Access Compliance Report Public Rights-of-Way (Curb Ramps)

Main Street: SIENNA_PKWY		Cross Street: KYLE_CT		Location:	SW
ADA ID: RPRK211101114409	Ramp Type: Type 1 - Perpendicular	Initial Pass/Fail: Fail	Overall Compliance: No	Severity Score:	2
Codes/Mitigation Info/Possible Solution			Field Measurements/Component Compliance

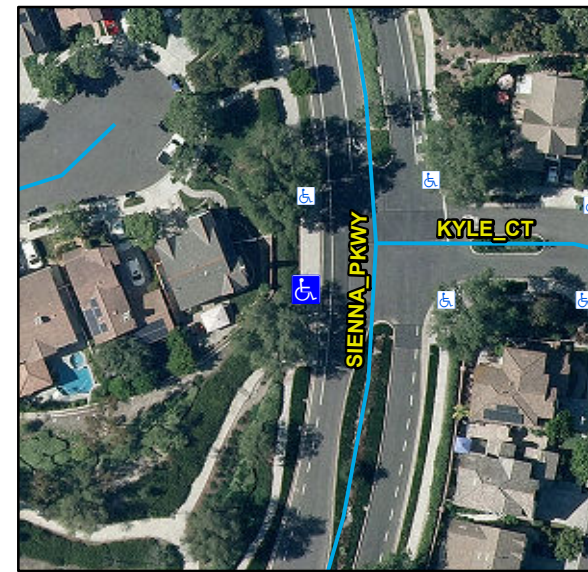
Compliance	Description	Data	Compliance	Description	Data
N/A	Ramp Length (in)	69	N/A	Flare Type LT	
Yes	Ramp Width (in)	48			N/A
Yes	Ramp Run Slope (%)	8.2	N/A	Flare Slope LT (%)	N/A
No	Ramp Cross Slope (%)	2.3	N/A	Flare Traversable LT	N/A
N/A	Landing Present	N/A	N/A	Flare Type RT	
N/A	Landing Length (in)	N/A			N/A
N/A	Landing Width (in)	N/A	N/A	Flare Slope RT (%)	N/A
N/A	Landing Run Slope (%)	N/A	N/A	Flare Traversable RT	N/A
N/A	Landing Cross Slope (%)	N/A	N/A	DWS Provided	N/A
N/A	Landing Movement Obstructed?	N/A	N/A	DWS Contrast	N/A
	Landing Movement Type	N/A	N/A	DWS Length (in)	N/A
N/A	Landing Shared	N/A	N/A	DWS Full Width	N/A
N/A	Clear Space	N/A	N/A	DWS Offset Left (in)	N/A
N/A	Clear Space To Crosswalk (in)	N/A	N/A	DWS Offset Right (in)	N/A
N/A	Marked Crosswalk 1	No	N/A	Marked Crosswalk 2	N/A
	Crossing 1 Direction	E		Crossing 2 Direction	N/A
	Marked Crosswalk 1 Width (in)	N/A		Marked Crosswalk 2 Width (in)	N/A

N/A	Ramp Inside Crosswalk 1	N/A	Yes	Ramp Inside Crosswalk 2	N/A
	Crossing 1 Slope (%)	1.7		Crossing 2 Slope (%)	N/A
	Crossing 1 Cross Slope (%)	1.4		Crossing 2 Cross Slope (%)	N/A
N/A	Gutter Ponding	N/A	No	Curb Slope	14.7
Yes	Gutter Lip Height (in)	0		Road Run Slope (%)	N/A
N/A	Gutter Run Slope (%)	N/A		Road Cross Slope (%)	N/A
N/A	Gutter Cross Slope (%)	N/A			
Yes	Overall Surface Condition: Acceptable		No	Perp Joint Present	No
	Cross Gutter Present?	No		Spandrel Present?	No
	Replace Cross Gutter?	N/A		Replace Spandrel?	N/A

Possible Solutions:

Remove & Replace Entire Ramp.
